**COMPREHENSIVE LONG-TERM ENVIRONMENTAL ACTION NAVY (CLEAN II)**  
**Northern and Central California, Nevada, and Utah**  
**CONTRACT Number N62474-94-D-7609**  
**Contract Task Order 007**

**HUNTERS POINT SHIPYARD**  
**SAN FRANCISCO, CALIFORNIA**

**ENGINEERING EVALUATION/COST ANALYSIS**  
**SITE IR-1/21: INDUSTRIAL LANDFILL**  
**GROUNDWATER PLUME**  
**FINAL**

**July 26, 1996**

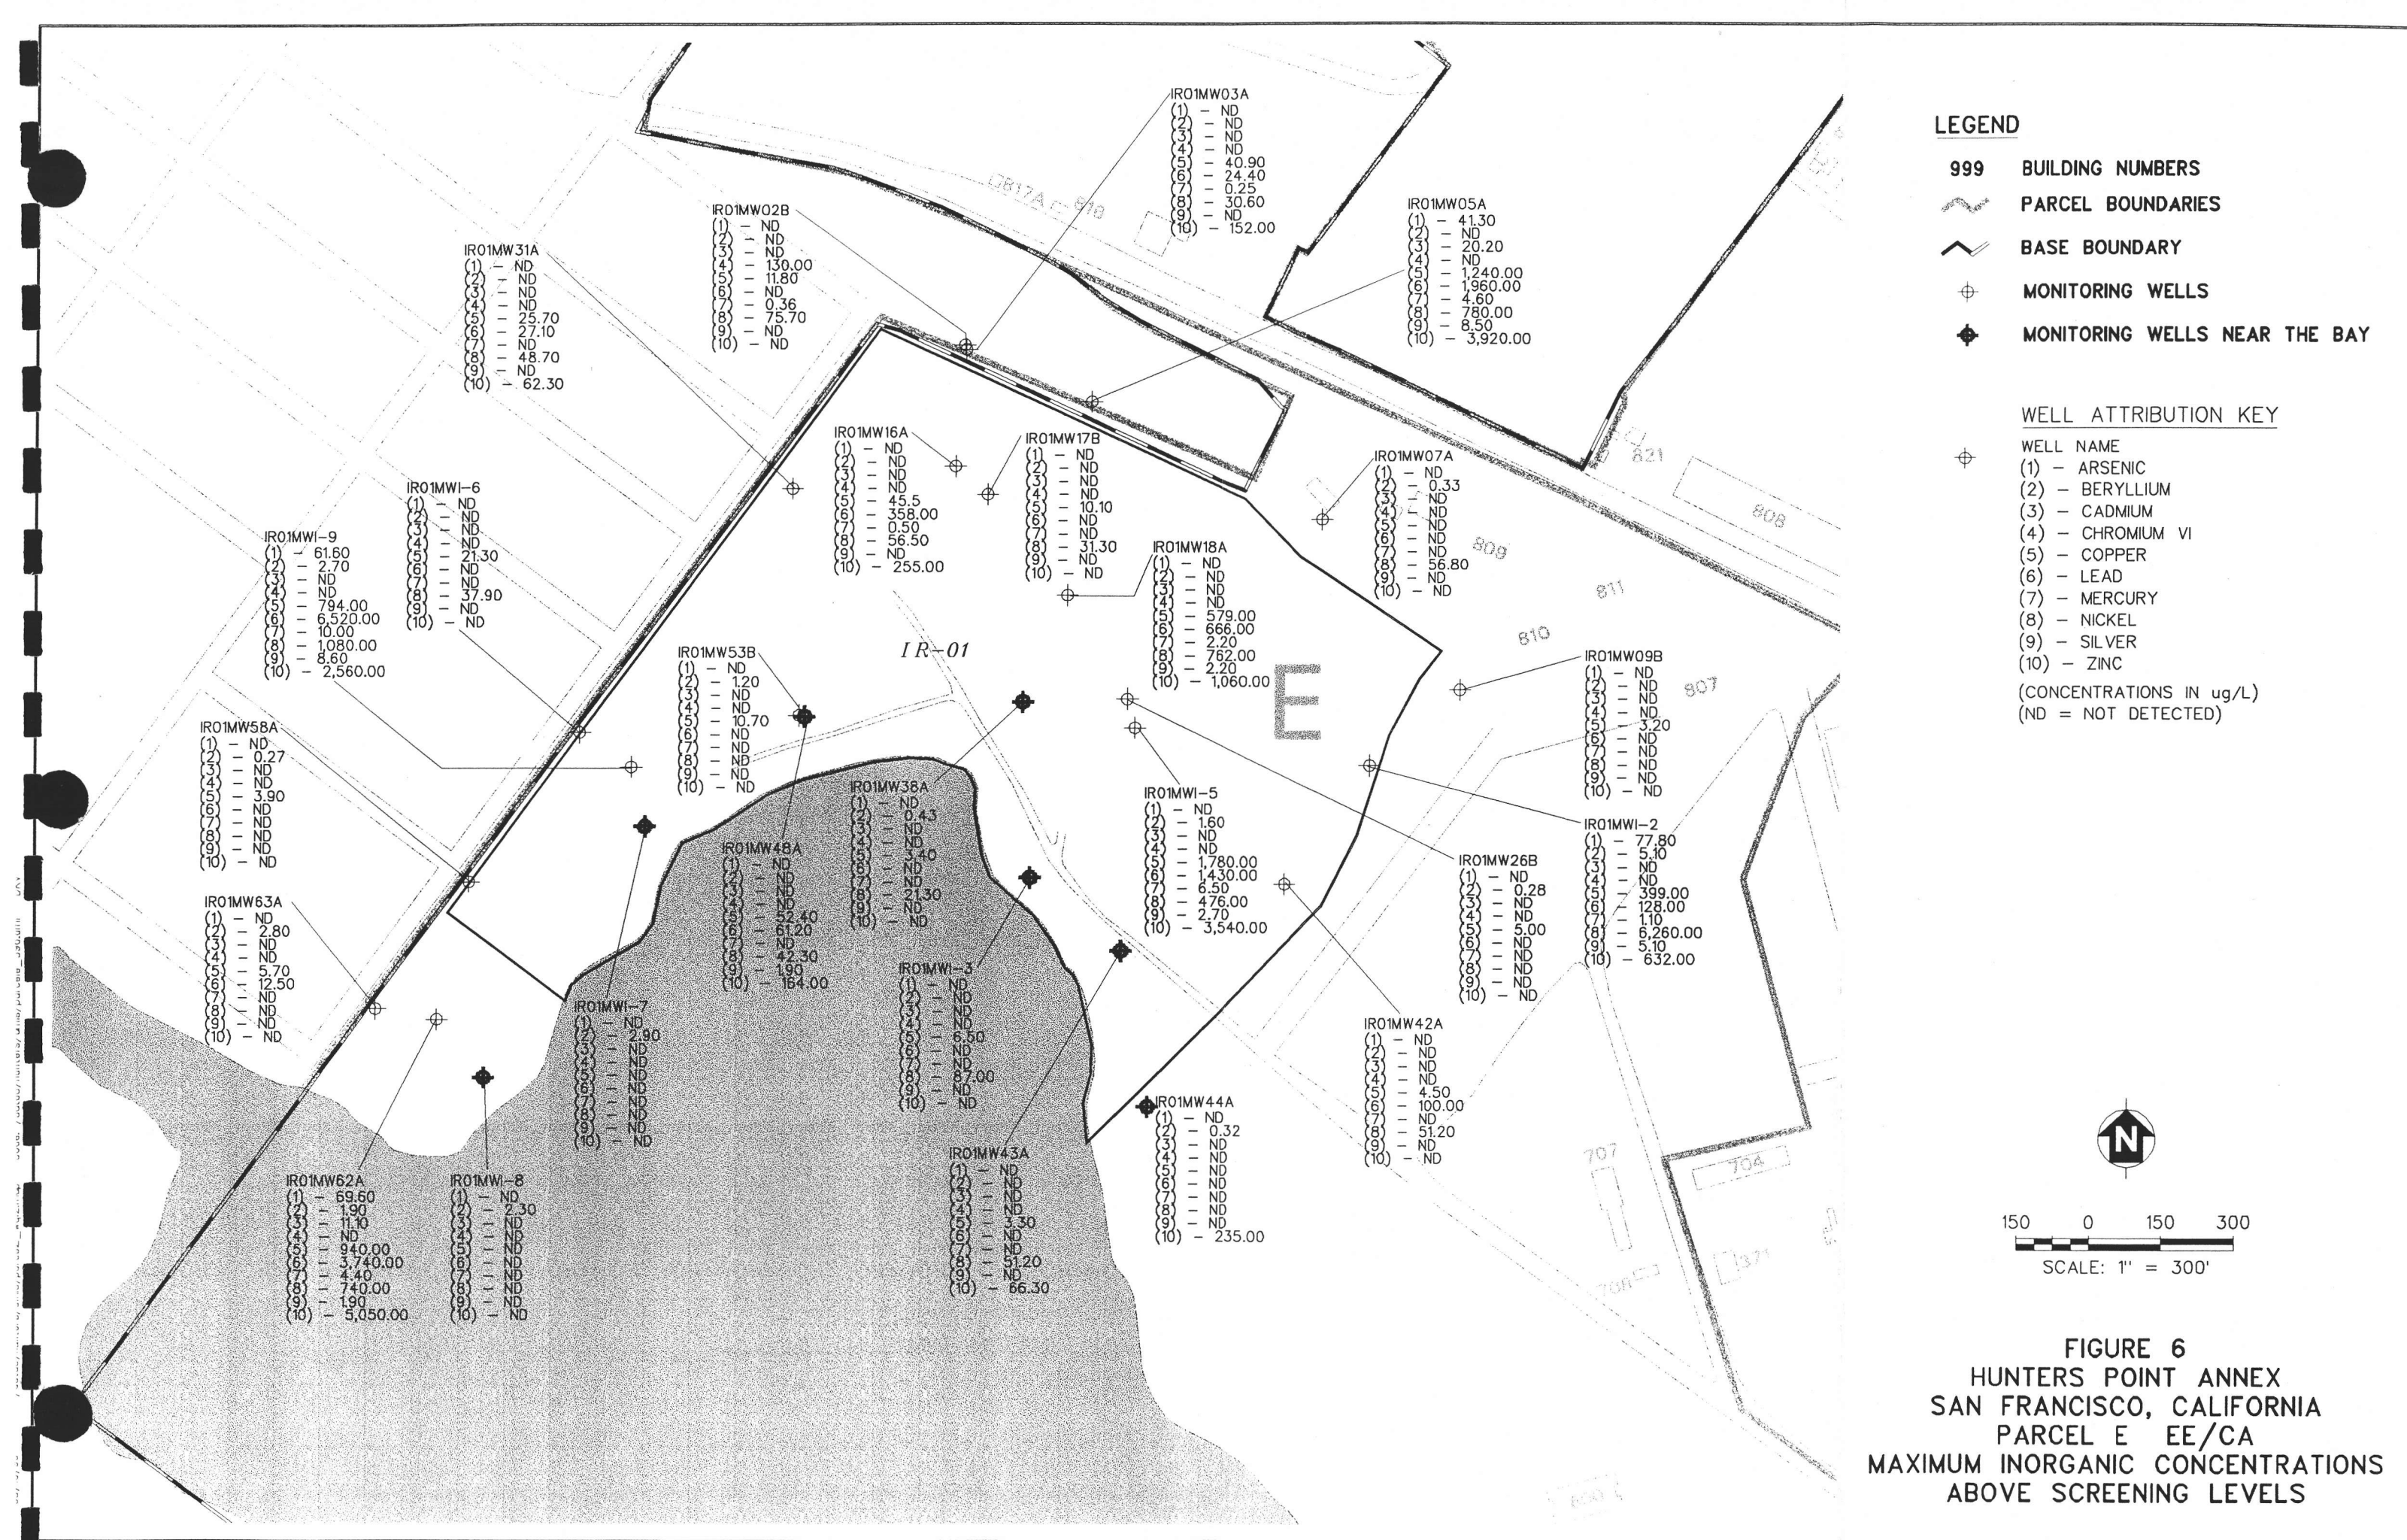
10. **Comment:** Section 2.8.3, page 38, last paragraph: Appears that majority of wells (12) have hits of PCB contaminants. Why the discrepancy between the text and the figure? This paragraph also states that PAH [polycyclic aromatic hydrocarbon] and PCB detections are limited to the southeast corner, whereas Figure 5 shows PAH detections scattered over the site.

11. **Comment:** Figure 5: Please include a debris zone on Figure 5.

**Response:** The text and figure were reviewed and PCBs were detected in only 11 wells, not 12, as shown on Figure 5. The text has been revised to clarify the locations of PCB and PAH detections.

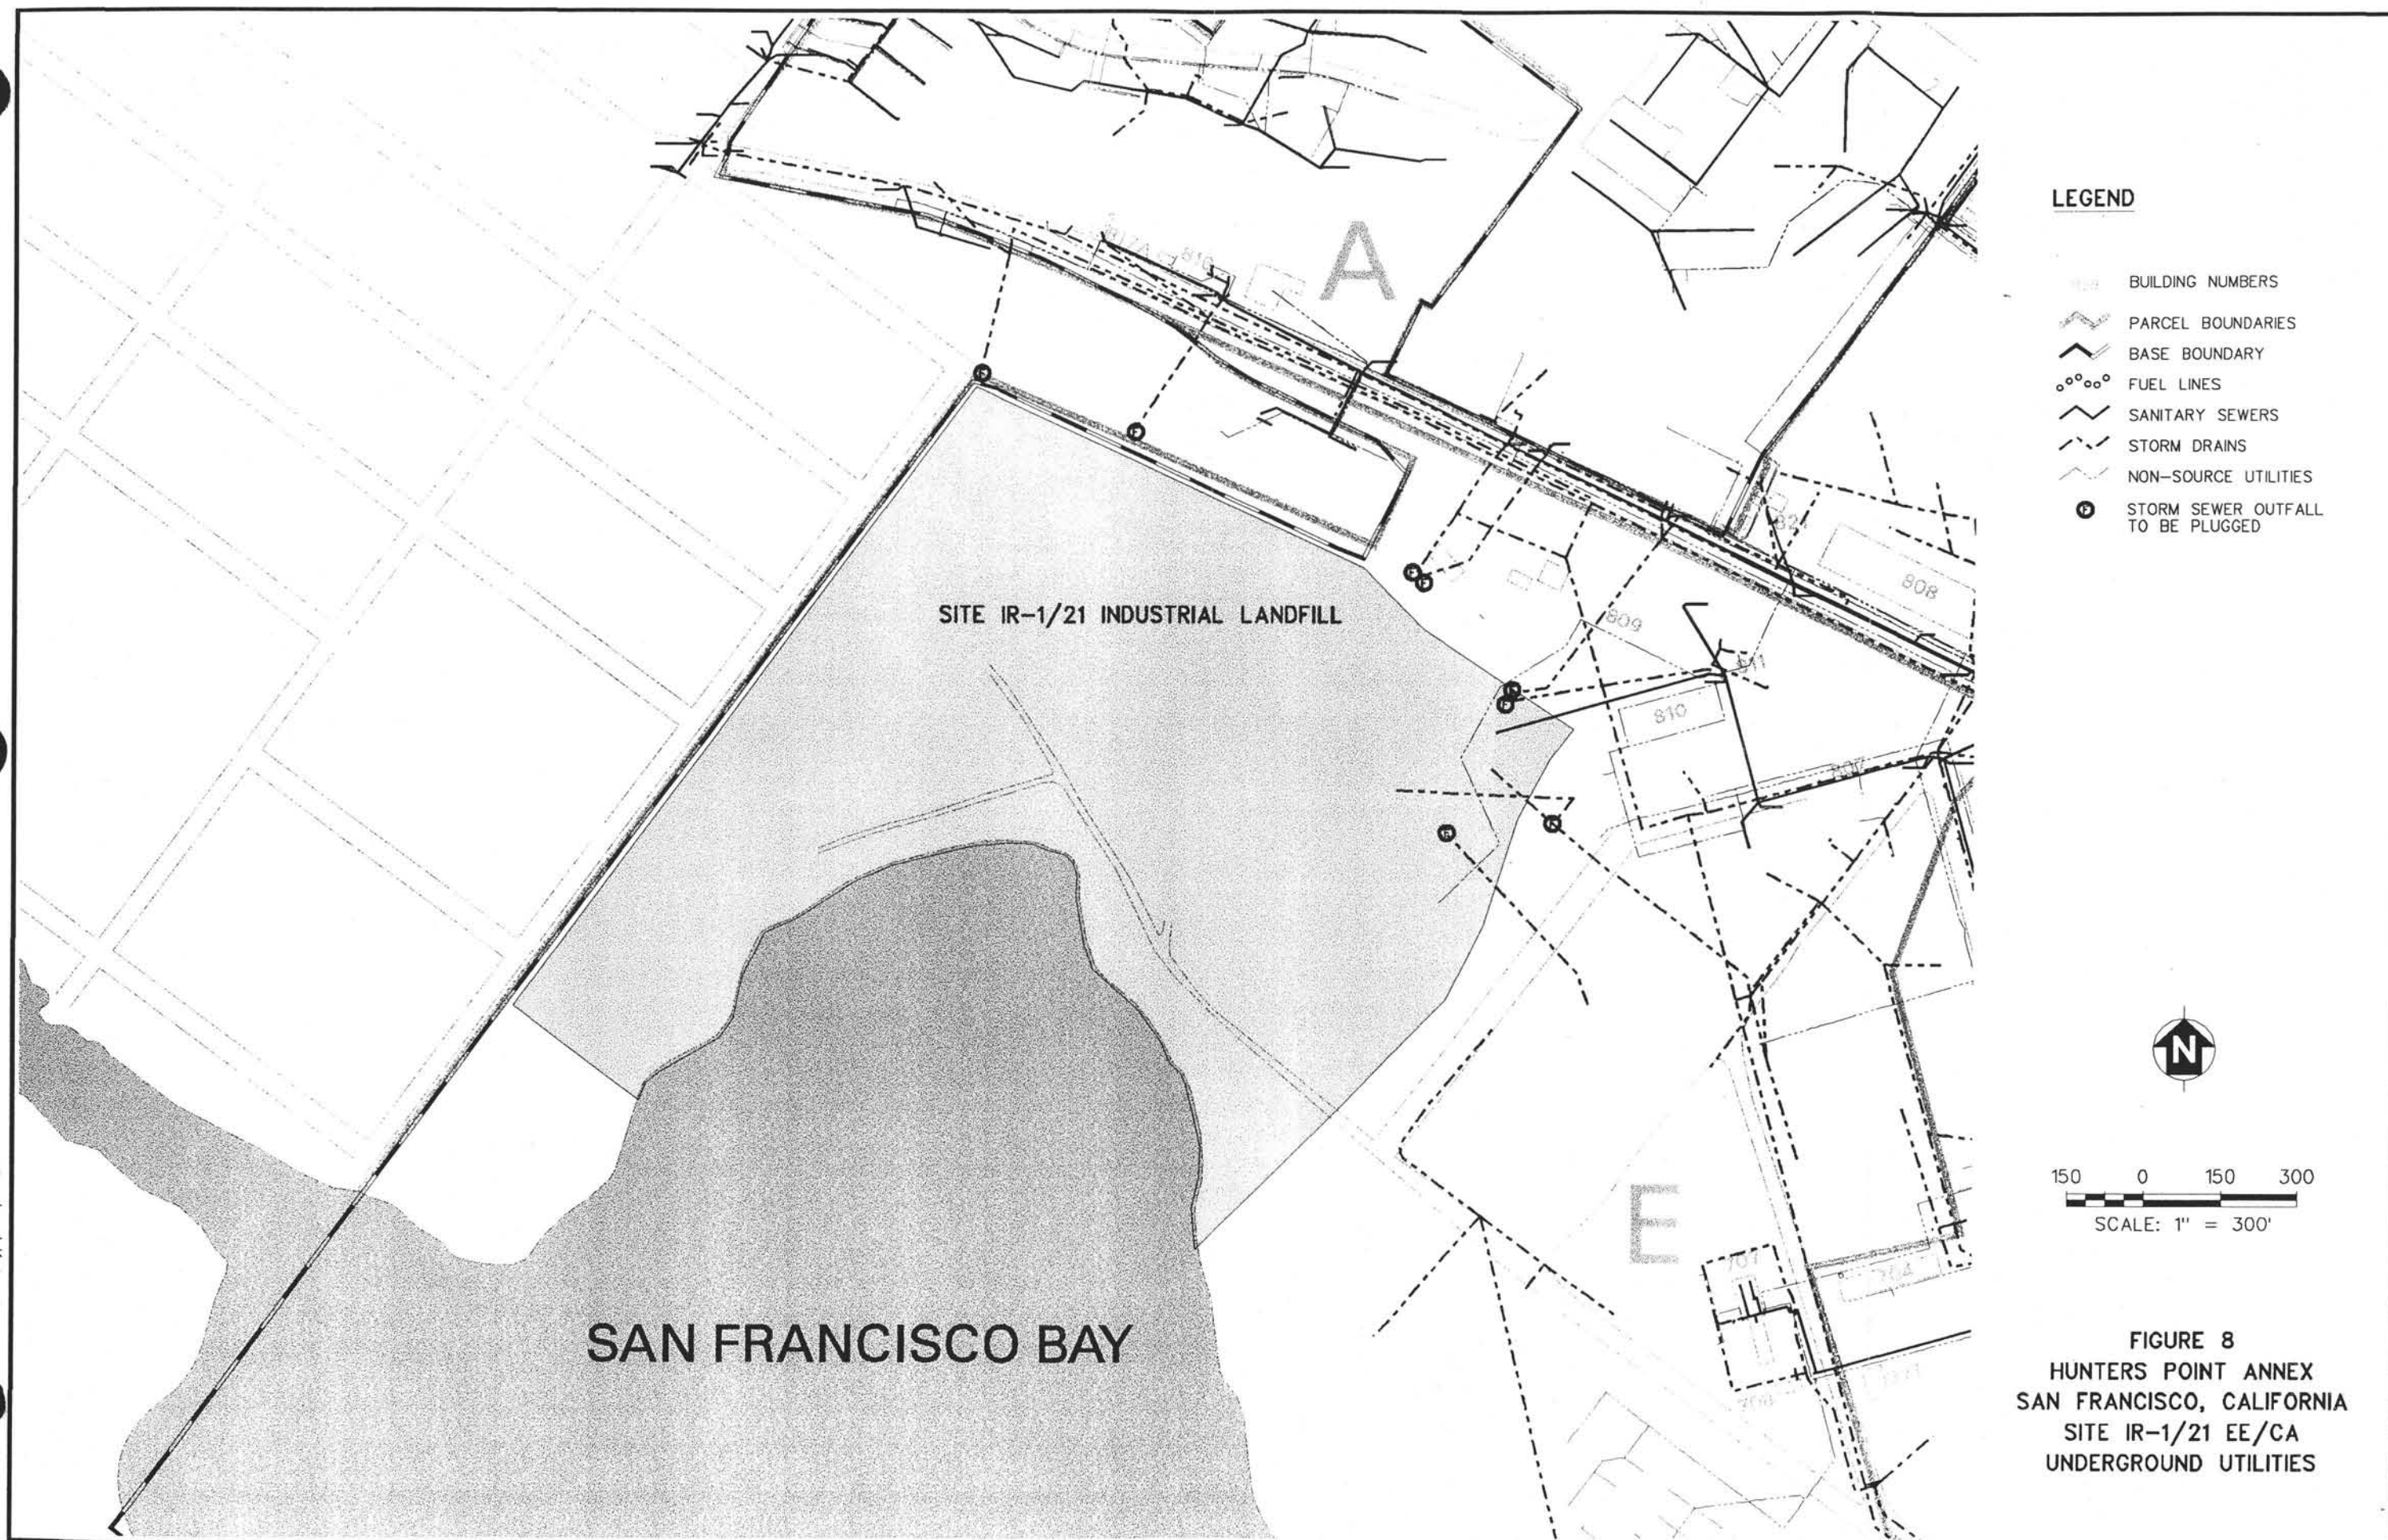
27. **Comment:** Figure 7: The figure of the approximate containment wall location was very helpful in understanding the preferred alternative. Could the approximate locations of the well points also be included on this figure?

**Response:** The Navy conducted a wetland delineation survey in January 1994 at Site IR-1/21 (PRC 1994). The nearest wetland boundary to the removal action area has been identified in Figure 7 of the final EE/CA. Groundwater levels in monitoring wells indicate that the groundwater is not connected to the wetland surface water. Therefore, including protection and restoration of wetlands at Site IR-1/21 in this removal action is not necessary. This removal action addresses containment of contaminated groundwater only. No aspects of the proposed removal action will physically occur in or affect wetland areas; therefore, wetlands will be protected but not restored.
